## **Access Compliance Report Public Rights-of-Way** (Island Curb Cuts)

Intersection ID: 3180 Main Street: JOHNSTON\_OEHLER\_RD Cross Street: SONG\_SPARROW\_LN Location: SE **ADA ID: 090F1F8D4F0A** Curb Cut Type: MedianRefuge2 Initial Pass/Fail: Fail **Overall Compliance: No Severity Score:** 25

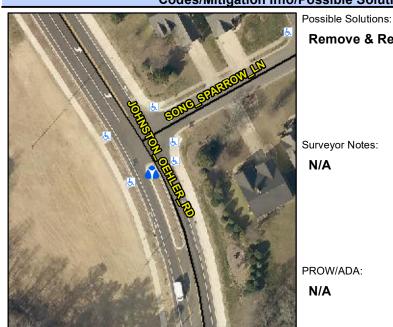
Yes	Refuge 1 Length (In)	48.0	N/A	Gutter 1 Ponding?	N/A
Yes	Refuge 1 Width (In)	95.0	N/A	Gutter 1 Lip Ht (In)	N/A
No	Refuge 1 Slope (%)	7.7	N/A	Gutter 1 Slope (%)	N/A
Yes	Refuge 1 X Slope (%)	1.1	N/A	Gutter 1 X Slope (%)	N/A
N/A	Painted X Walk1?	No	N/A	DWS 1 Provided?	N/A
N/A	X Walk 1 Direction	To NE	N/A	DWS 1 Contrast?	N/A
N/A	X Walk 1 Width (In)	N/A	N/A	DWS 1 Length (In)	N/A
N/A	Road 1 Slope (%)	1.9	N/A	DWS 1 Full Width?	N/A
N/A	Road 1 X Slope (%)	2.7	N/A	DWS 1 Offset (In)	N/A
Yes	Refuge 2 Length (In)	48.0	N/A	Gutter 2 Ponding?	N/A
Yes	Refuge 2 Width (In)	95.0	N/A	Gutter 2 Lip Ht (In)	N/A
No	Refuge 2 Slope (%)	9.0	N/A	Gutter 2 Slope (%)	N/A
Yes	Refuge 2 X Slope (%)	1.6	N/A	Gutter 2 X Slope (%)	N/A
N/A	Painted X Walk2?	No	N/A	DWS 2 Provided?	N/A
N/A	X Walk 2 Direction	To SW	N/A	DWS 2 Contrast?	N/A
N/A	X Walk 2 Width (In)	N/A	N/A	DWS 2 Length (In)	N/A
N/A	Road 2 Slope (%)	1.3	N/A	DWS 2 Full Width?	N/A
N/A	Road 2 X Slope (%)	2.8	N/A	DWS 2 Offset (In)	N/A

Remove & Replace Entire Refuge.
